**SNS 104020000-TR0008-R00**

# **SNS Drift-Tube Linac Recovery and Production Plan**

**December 2002**

**SNS DRIFT-TUBE LINAC RECOVERY AND PRODUCTION PLAN**

Figure 3 shows a metallographic section through a leaking drift-tube weld joint. In this typical case, the welder made three passes using very narrow welds of different depths.

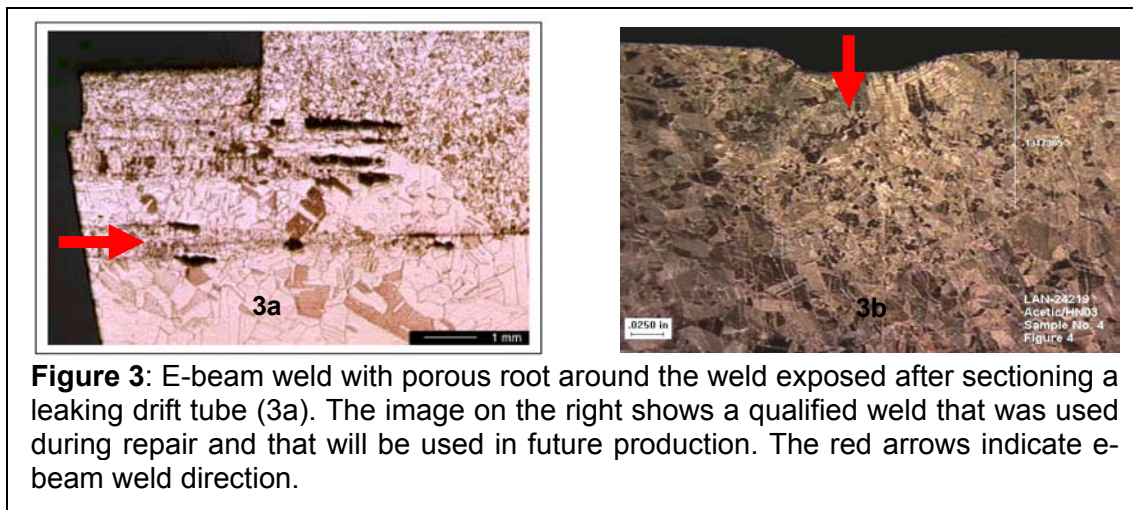
Each pass created porosity, and visible voids in the copper as can be seen in the right-hand side of Fig. 3a.
